12 September 2018

File No: R/2017/23/A and R/2017/22/A
Our Ref: 2018/474366

SSD 8875 (Pitt Street North) and SSD 8876 (Pitt Street South) Over Station Development Concept Proposals

Extract from Sydney Metro community booklet titled *"Pitt Street Over Station Development Concept State Significant Development Application Environmental Impact Statement Overview August 2018"*

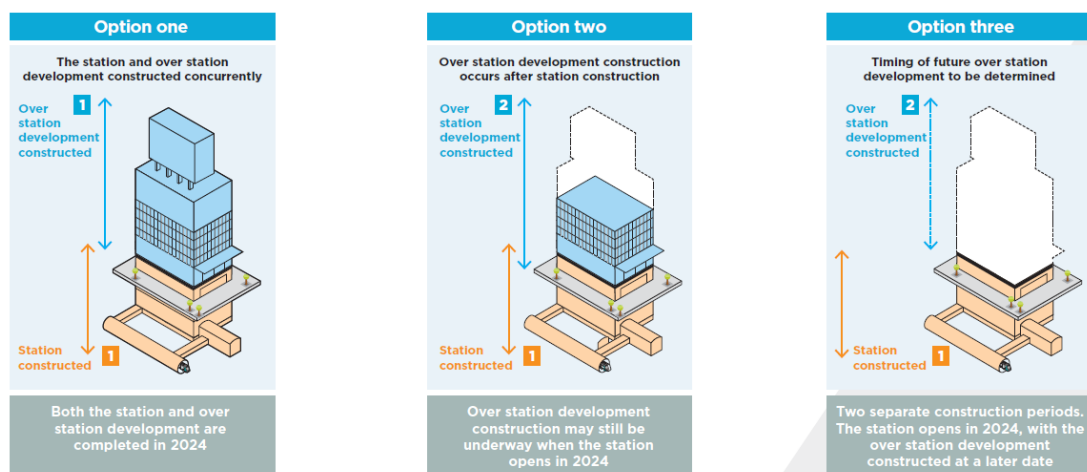
Any concerns by the proponent that a design excellence process in accordance with the provisions of Sydney LEP 2012 might extend the duration and completion of the OSD and station development directly contradicts the staging scenarios presented in both of the EIS documents and the Sydney Metro Pitt Street community handout.

Specifically, Option 3 suggests an approach where the station is constructed first with the OSD built at a later stage (refer extract below). It is entirely feasible that a design excellence competition can be completed without impacting on timelines already contemplated by the proponent for the delivery of the projects.

selected. **The applicant has completely failed to make the case for a waiver through their choice of benchmarks, and have undermined their rationale through their own published Options shown above.**
